ADDENDUM NO. 3

February 6, 2023

**SOLON ROBINSON ELEMENTARY SCHOOL ADDITIONS,
RENOVATIONS, AND RELATED WORK
Crown Point, IN 46307**

SHEET
ES002

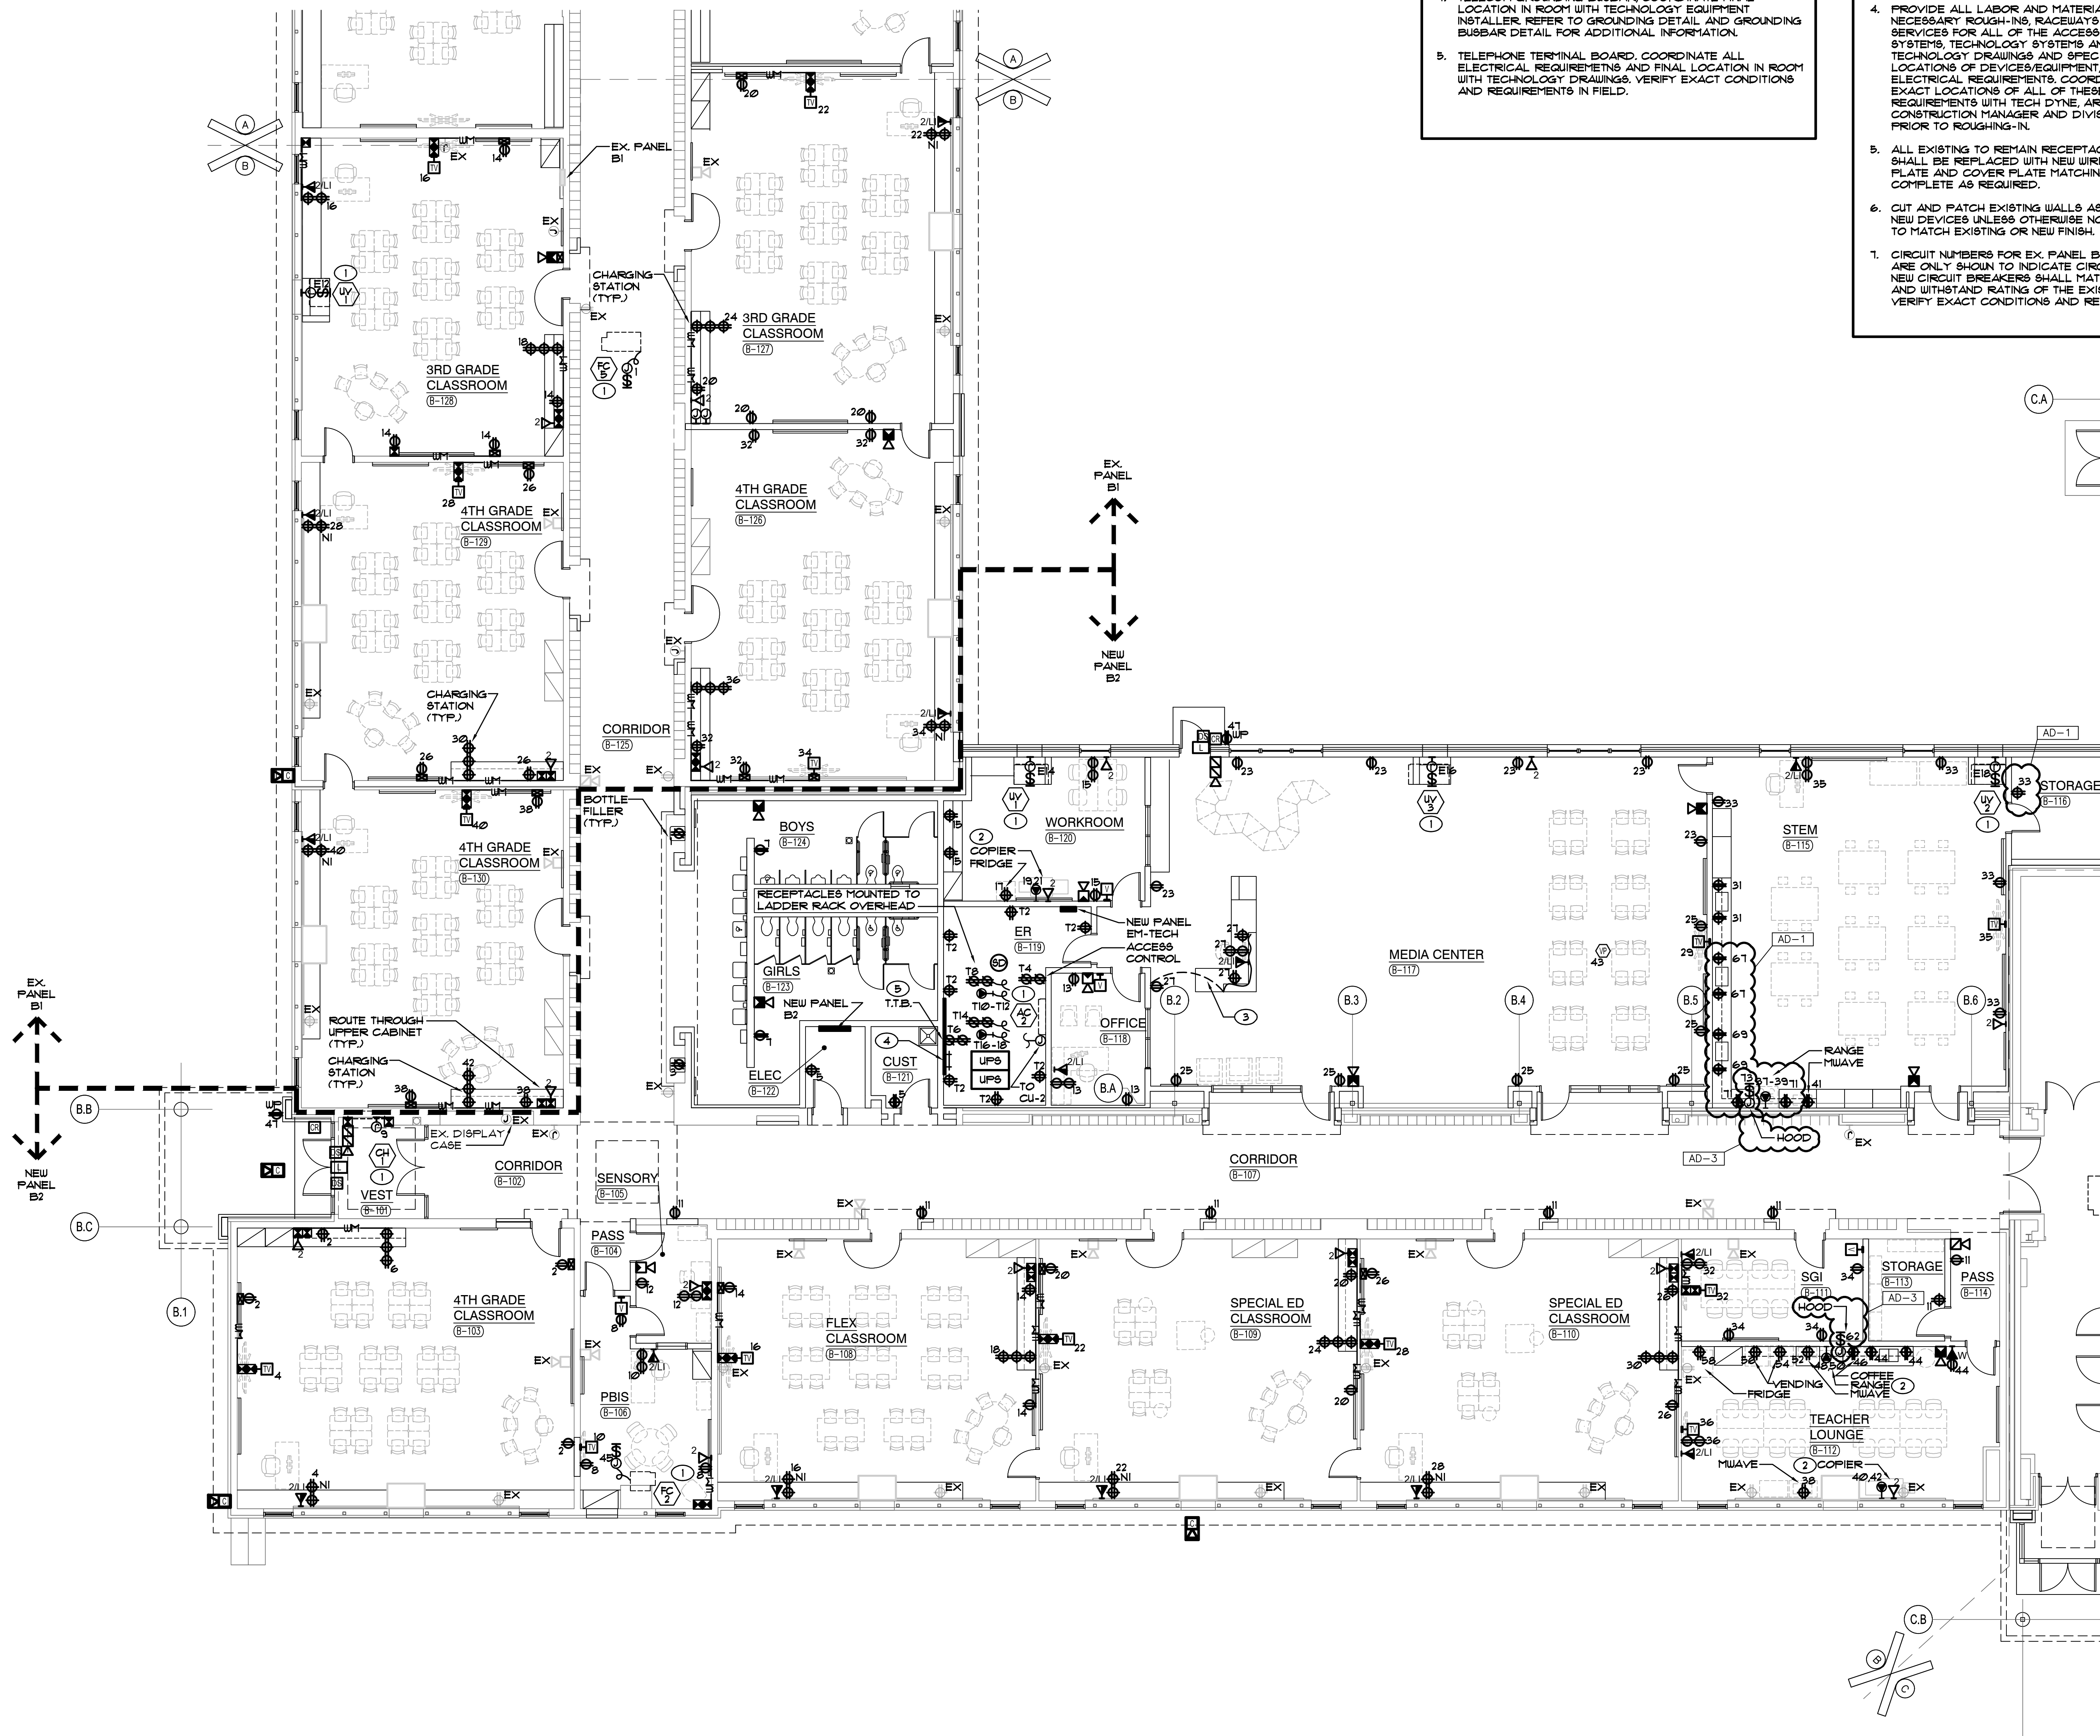
- A. Add General Note.
- B. Ex. Panel D1 location clarified.
- C. Add EA 1, EA2 and ED fixtures.
- D. Add Circuitry.
- E. Add Alternate Bid area.
